SUBJECT: Contract 9160  
SR99, AWV-Replacement South Access SR99 Connections  
**CHANGE ORDER #022**  
**SR99 Roadway Settlement Repair**

CONTRACT NO: 009160 FEDERAL AID NO:  
CONTRACT TITLE: SR 99, ALASKAN WAY VIADUCT - REPLACEMENT SOUTH ACC  
CHANGE ORDER NO: 22 SR99 ROADWAY SETTLEMENT REPAIR

**DESCRIPTION OF WORK**

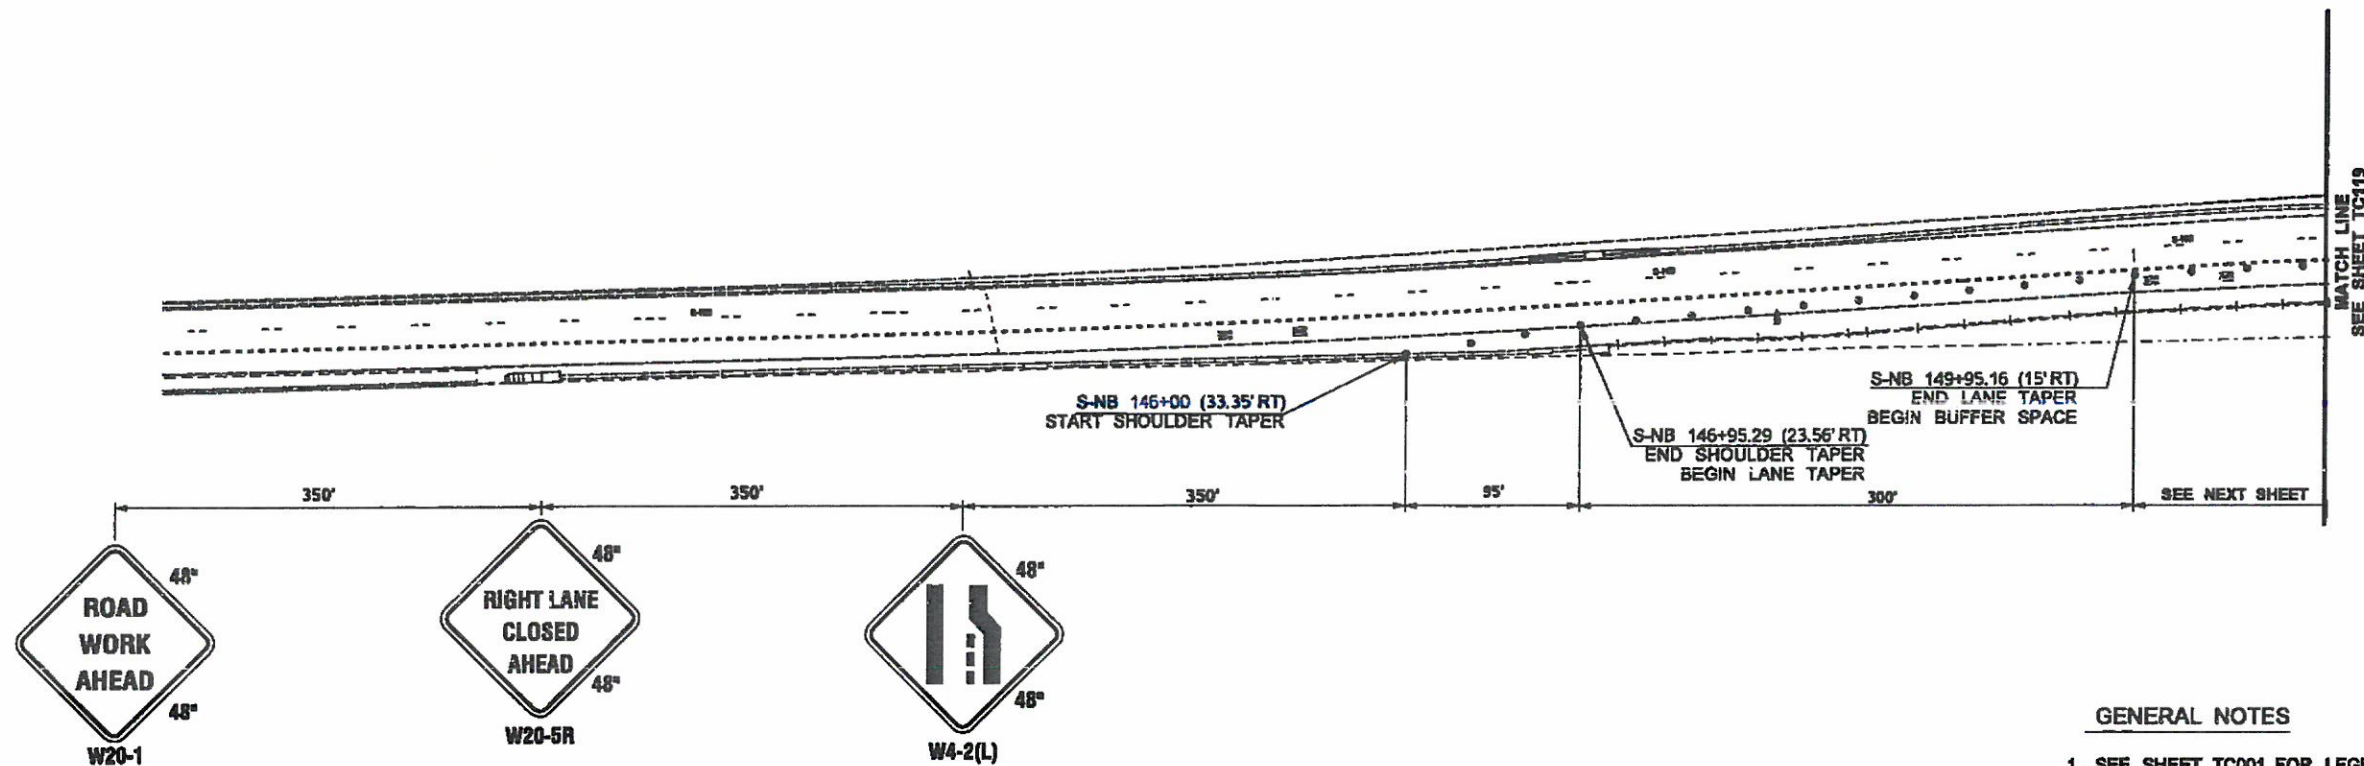
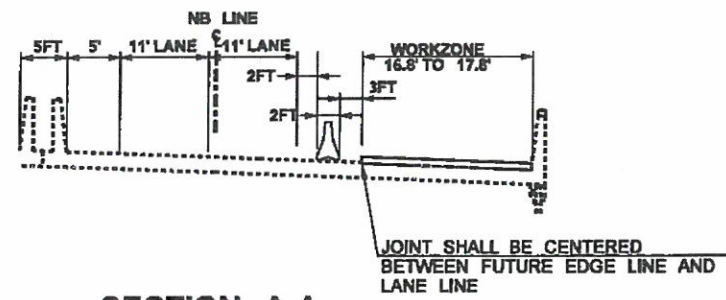
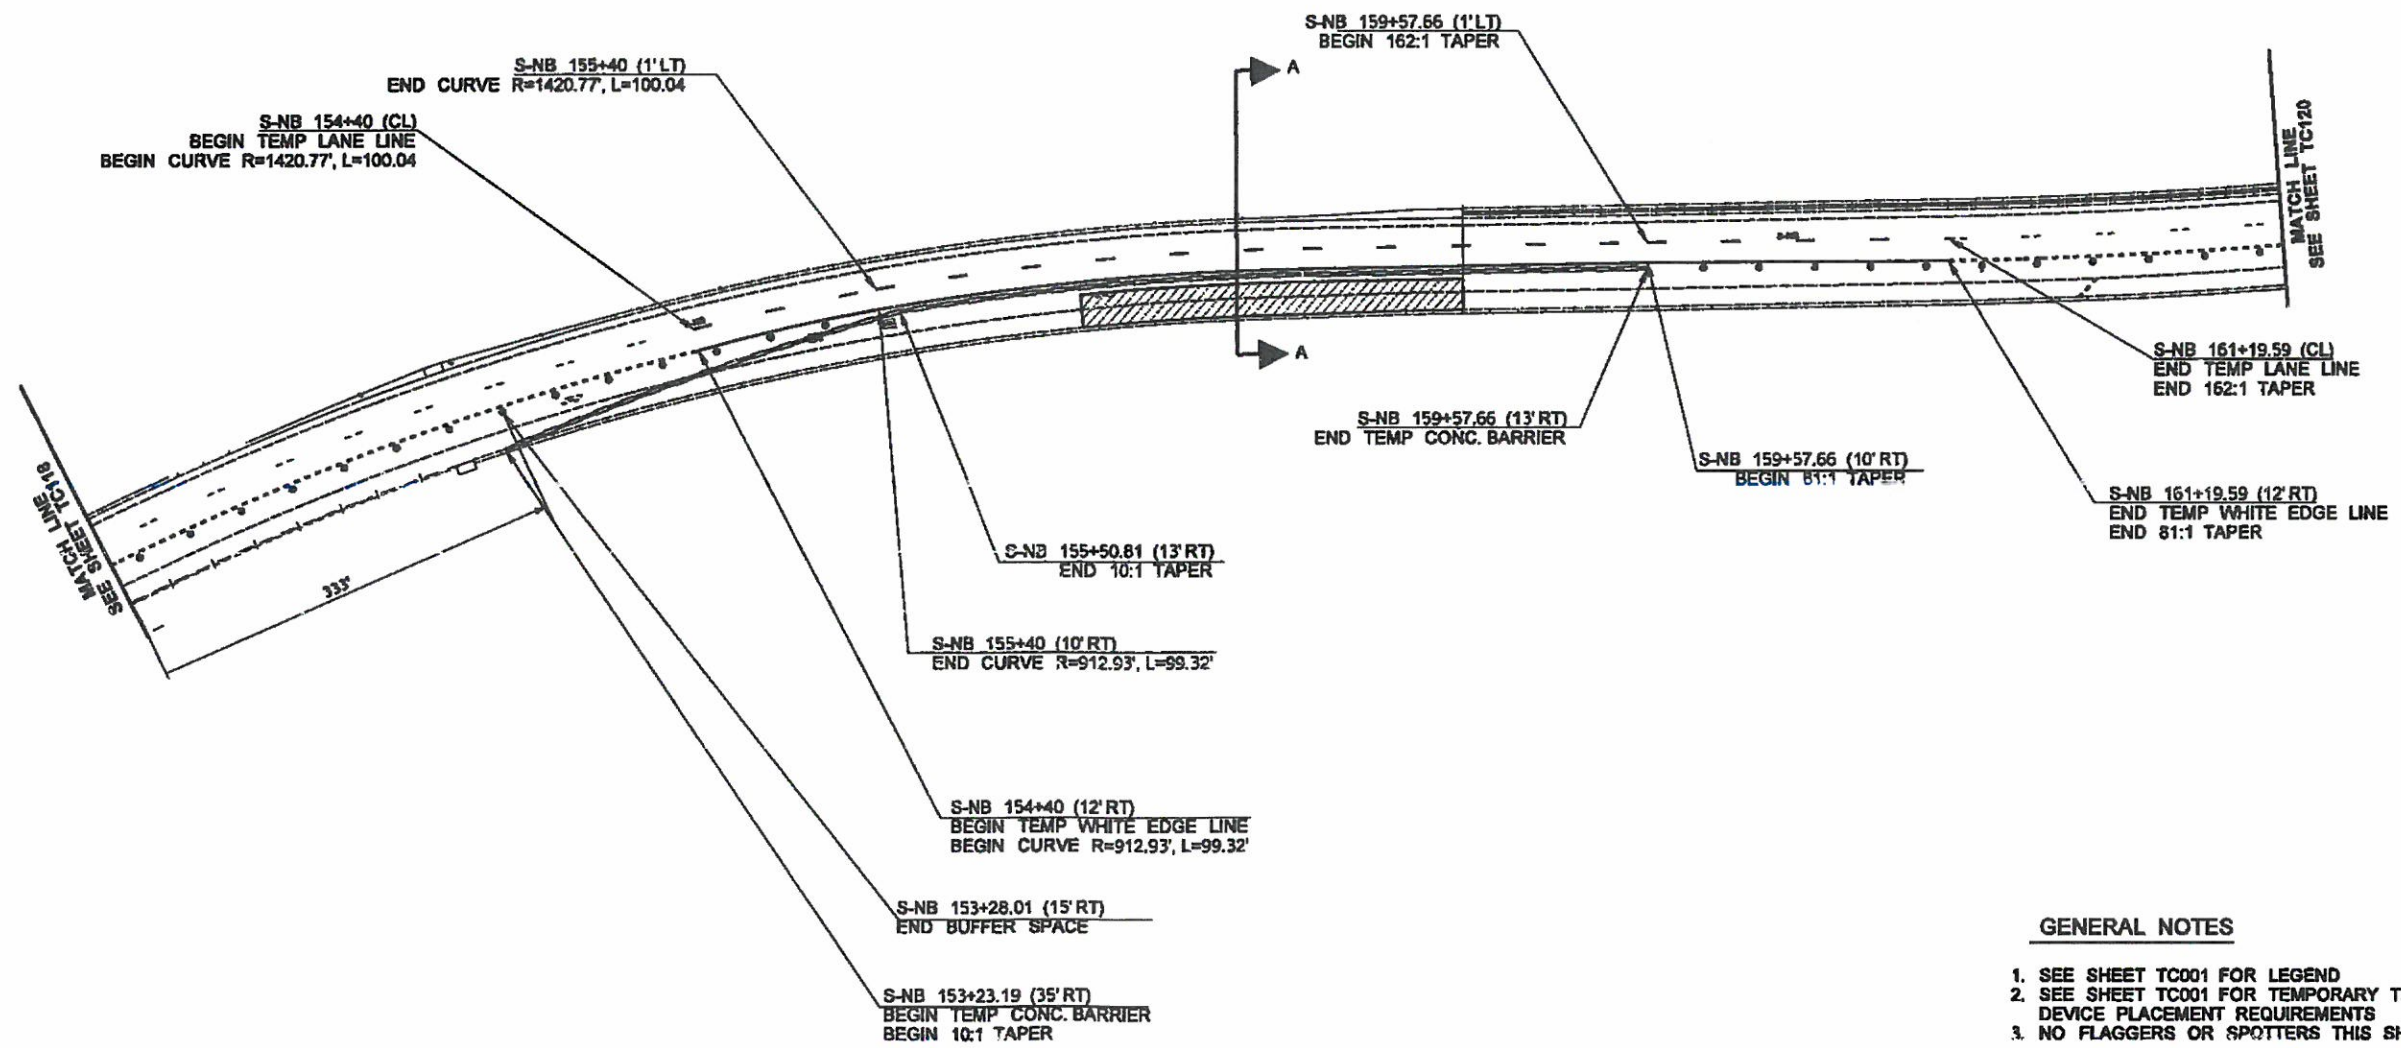
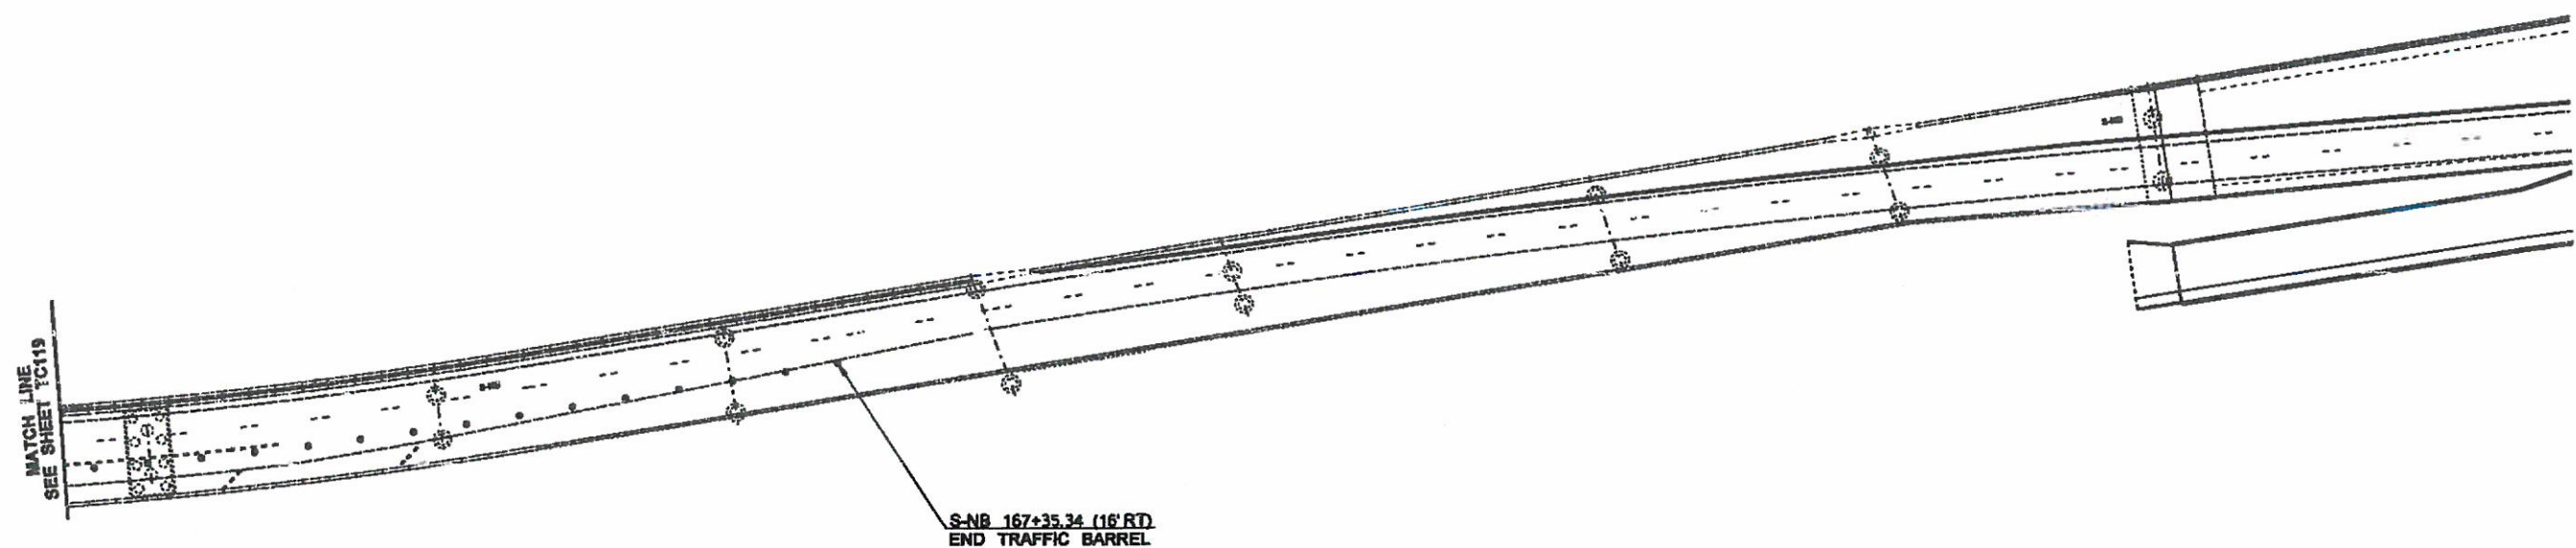
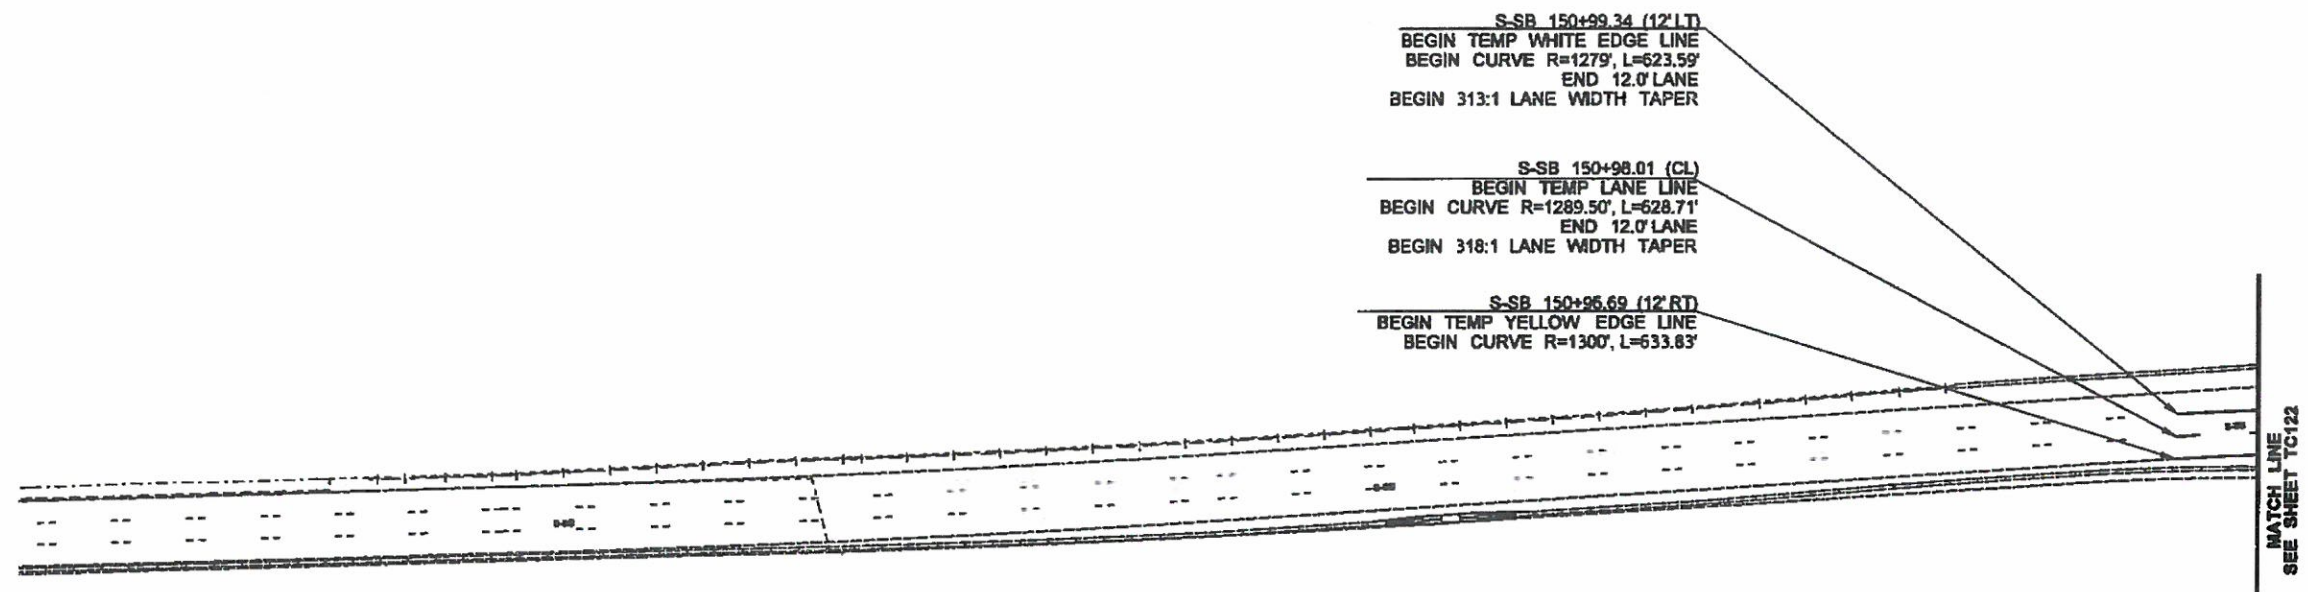
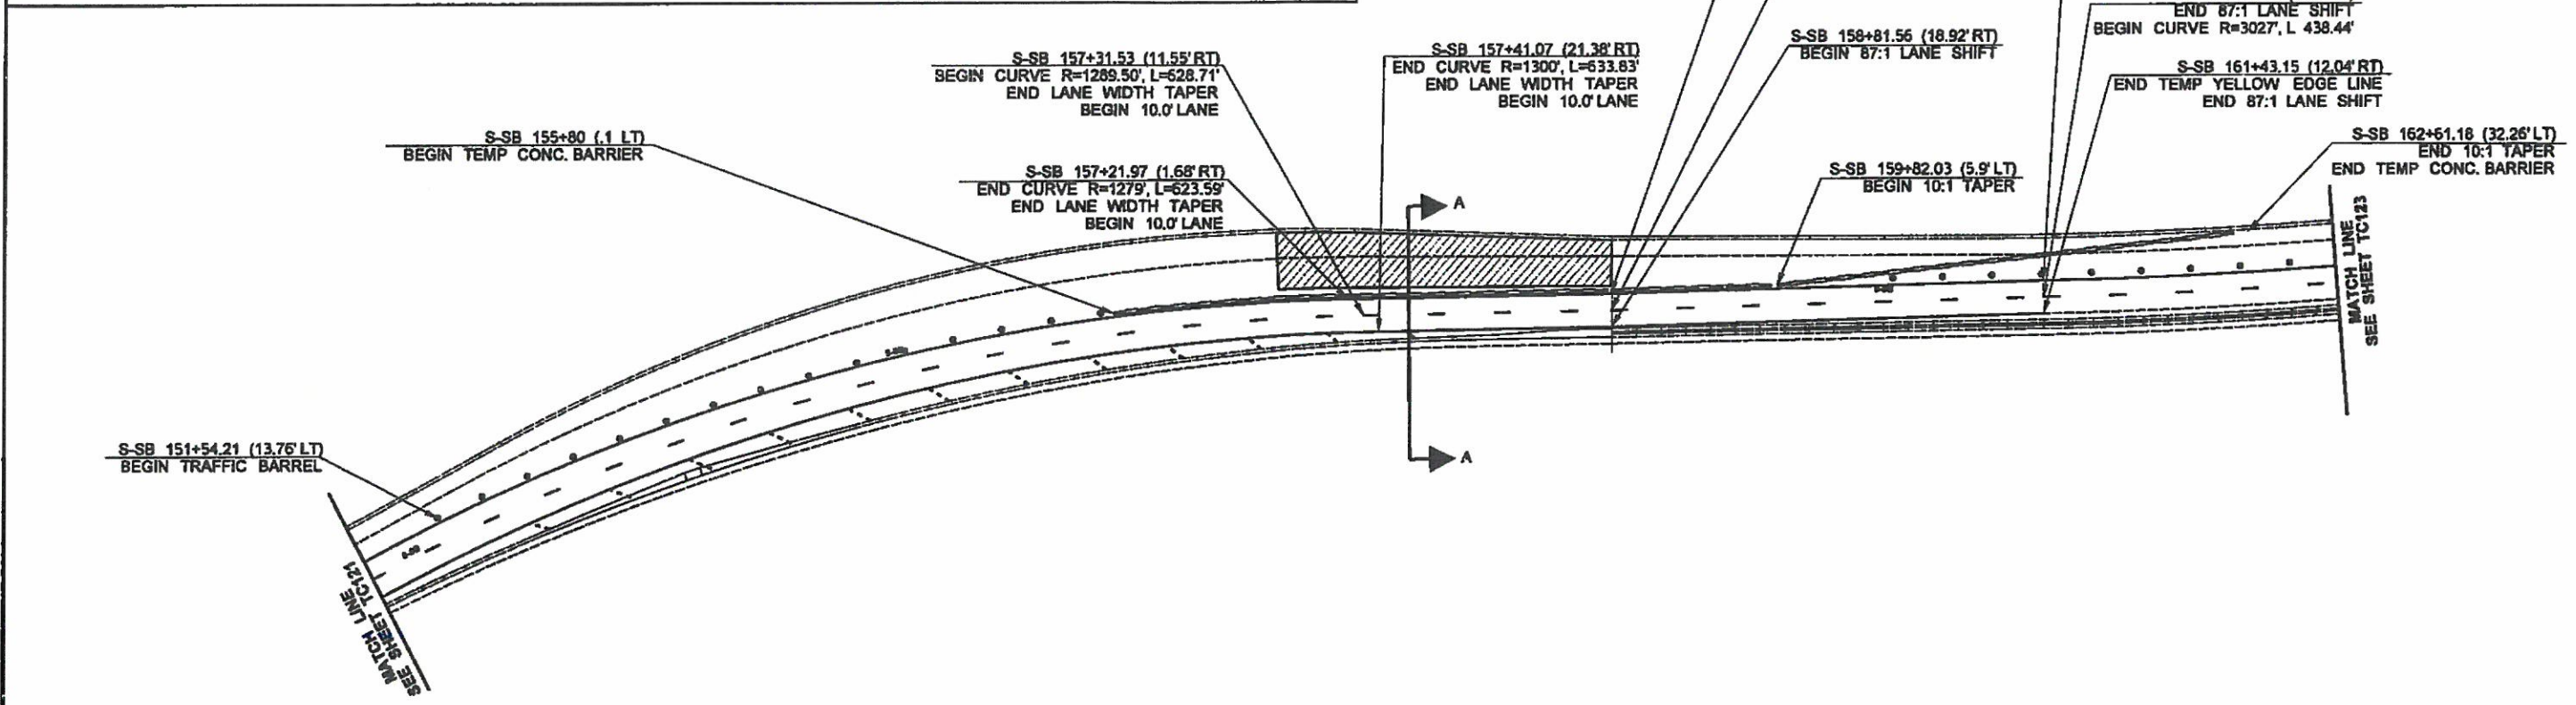
- S-NB 157+13.39 (16.95' LT) to S-NB 158+57.58 (16.51' LT)
  - S-NB 157+12.55 (35.83' RT) to S-NB 158+57.58 (34.86' RT)
- (6) Implements the traffic control as shown in the plans. Adds temporary barrier and temporary striping to shift traffic in order to maintain access.
